Town of Medley

Date:	April 13, 2015
Subject:	ITB FOR DANNY MEEHAN RECREATIONAL FIELD IMPROVEMENTS PROJECT
Solicitation Number:	ITB 2015-001
OCPDS Number:	PR-1301
Opening Date / Time:	April 16, 2015 at 3:00 PM
ADDENDUM Number:	3

ITB No. 2015-001 / Medley DMRF Improvements - Danny Meehan Park

Bid Questions

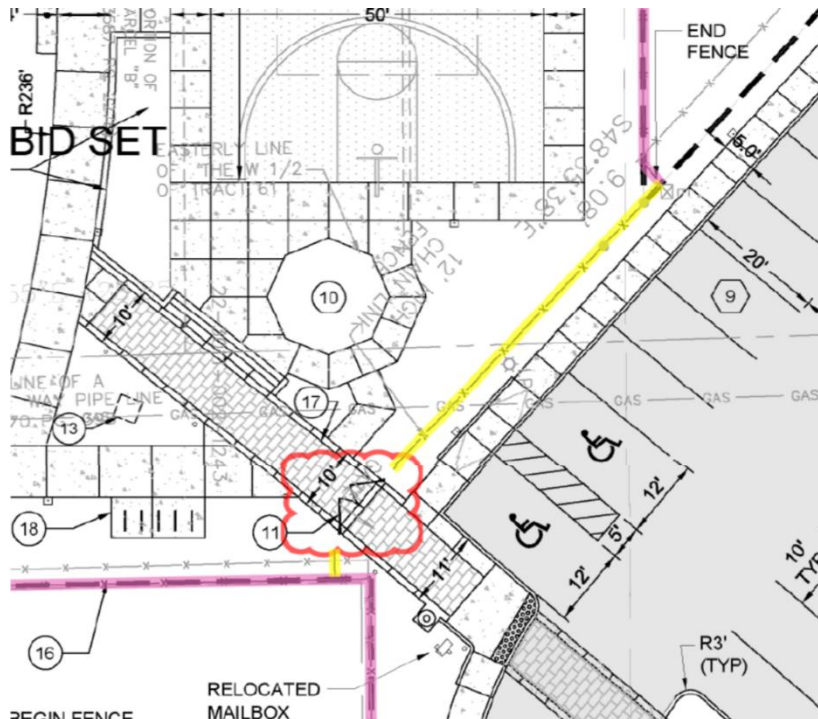
- Please clarify if the electrical disconnects and water line (H.B) enclosed within a four foot chain-link fence enclosure on the northeast of the existing basketball court to be removed/demolished, if the underground conduit and water line are to be abandoned in place, if the underground is to be abandoned in place do the wire need to be pulled out and the water line capped.

Please refer to Specification Section 31 00 00 3.5. Unless otherwise noted on the site electrical plan existing electrical disconnects shall be removed and demolished. The existing water line service shall be removed back to the water main tap and capped at the service tap in accordance with MDWASD and City of Medley utility standard specifications and details and as directed by the city or utility inspector.

Figure 1 - C-200

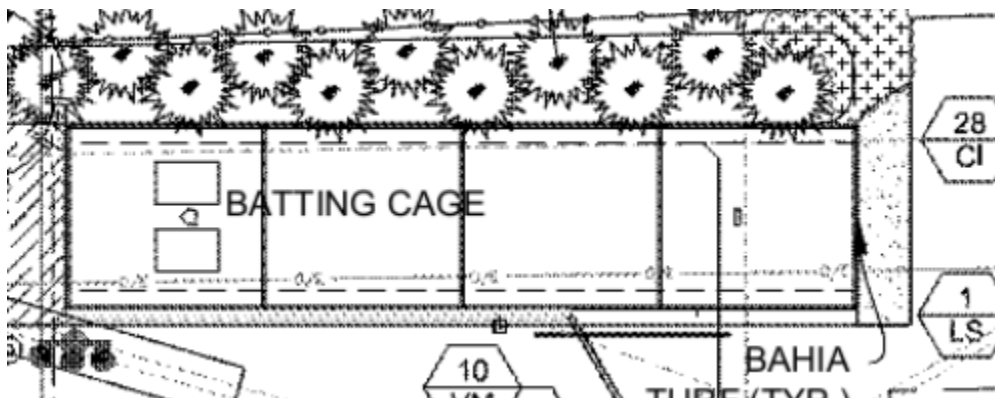
36. Plans keep on referring to Architectural Drawings, however there are none. Please advise.

2. SEE **ARCHITECTURAL** SITE PLAN FOR FIELD / COURT DIMENSIONS, LAYOUT, BRICK PAVER DETAILS, AND DETAILS.

Please refer to Landscape Architectural drawings L series.

Figure 2- L201

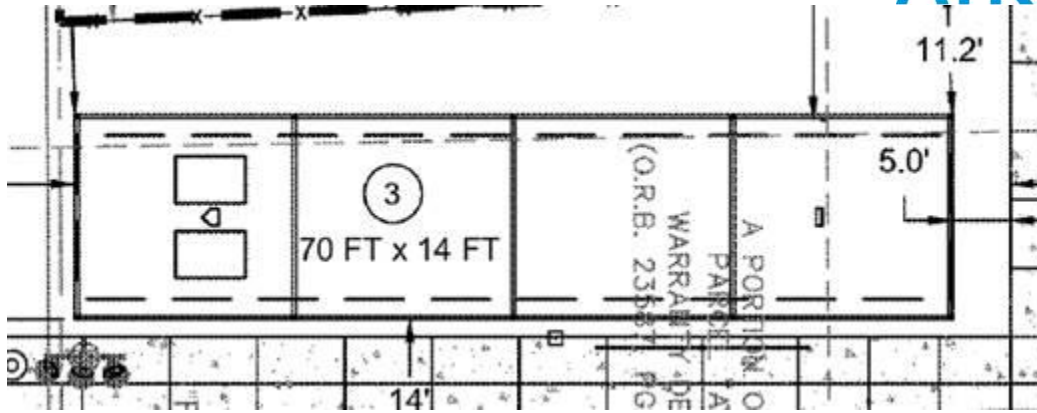
37. The existing playground that is to have recycled matting requires a 4" concrete base underneath the matting. Plans do not indicate any base. Is the base and the matting existing?
38. The plans do not indicate the type of floor for the batting cage. Will the batting cage floor be sod, asphalt or concrete? Please advise.

Figure 4 - Detail 1/L151

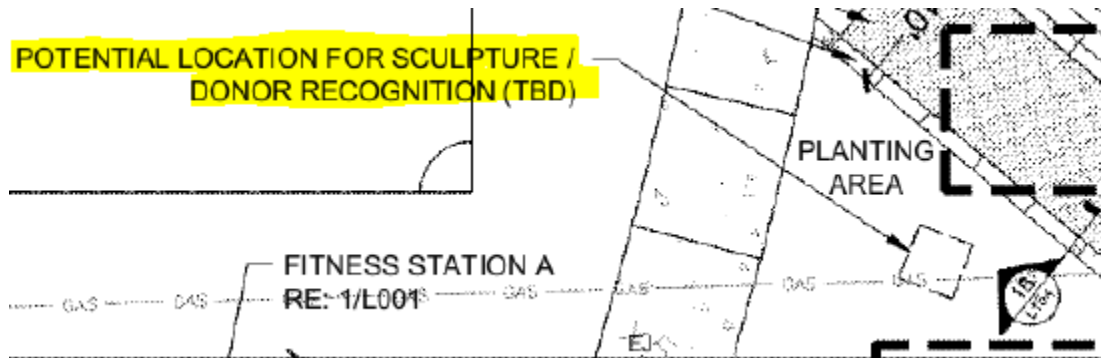
39. L101 indicate that the soccer goal are NIC. Please verify if this true.
40. Detail 1/L151 makes a reference to a potential location for sculpture/donor recognition (TBD). Will a footing be required?
